Ref: **2018/6105/P**

RE: 2018/6105/P, 1 St Mark's Crescent London NW1 7TS

As the owners of 2 St. Marks Crescent, we hereby object to the planning application at 1 St. Marks Crescent.

Figure 3. Excavated sites

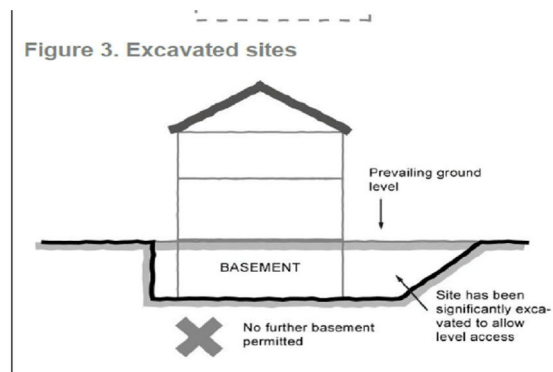
g. not be built under an existing basement;

Figure 3 provides an illustration of what LB Camden consider unacceptable.

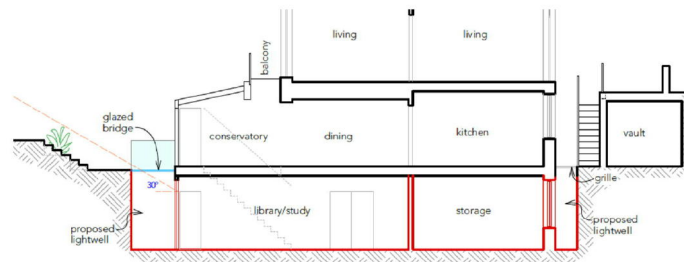
The section below shows the proposed basement underneath an already excavated floor.

The proposed basement is therefore not in accordance with criteria g.
